SUBJECT: PROVISION OF ADDITIONAL INFORMATION

REF: Byproduct License Number: 34-26659-01
Docket Number: 030-33884
Mail Control Number: 577345
NRC Letter Dated: 21 May 2012

ATTACHMENT 1: RESPONSES TO REQUEST FOR INFORMATION

ATTACHMENT 2: COPY OF LAMP SLEEVE FOR LAMP CONTAINING Kr-85

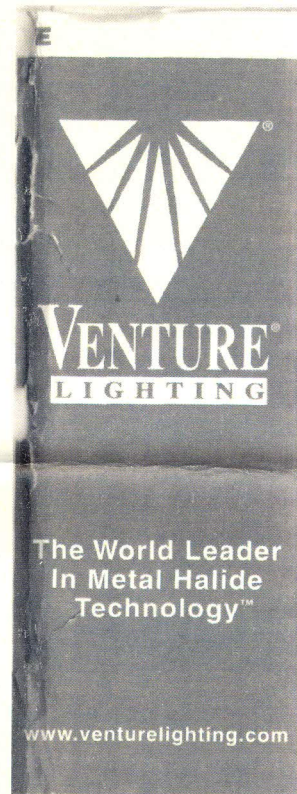
- "3. Section 32.14(b)(6) requires the applicant to submit information concerning the proposed method of labeling or marking each units, and its container, with the identification of the manufacturer or initial transferor of the product and the byproduct material in the product. Please submit and provide a copy identifying the information that will be included in the label."

For each lamp containing Kr-85, the glass envelope will be labeled with the model number of the lamp. The cardboard sleeve covering each shipped lamp will be labeled with the name of the manufacturer, and with the symbol, "Kr-85". Attachment 2 contains a copy of a lamp sleeve, for a lamp that will contain Kr-85.
